V2500 Propulsion System — Nacelle

SERVICE BULLETIN

NACELLE — POWERPLANT — SEAL, PYLON APRON, AFT — MODIFICATION OF

V2500-NAC-71-0212

Modify the Left Aft Pylon Apron
Figure 1 (Sheet 1)

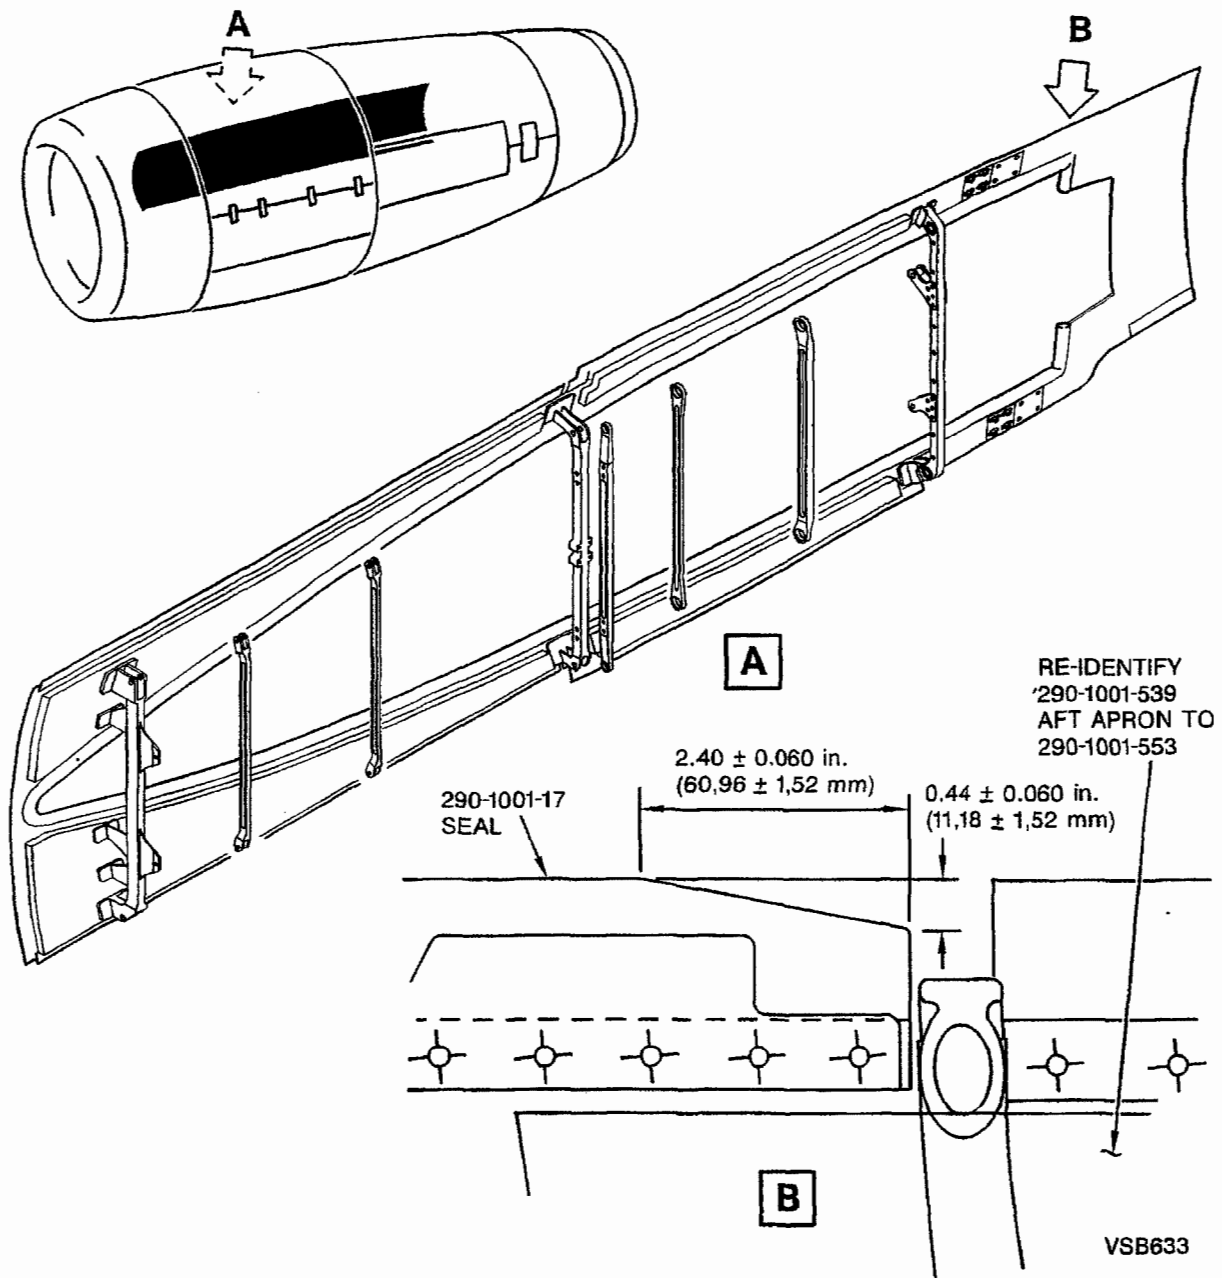
- (1) Remove material from the upper forward blade seal to the dimensions shown in Figure 1.
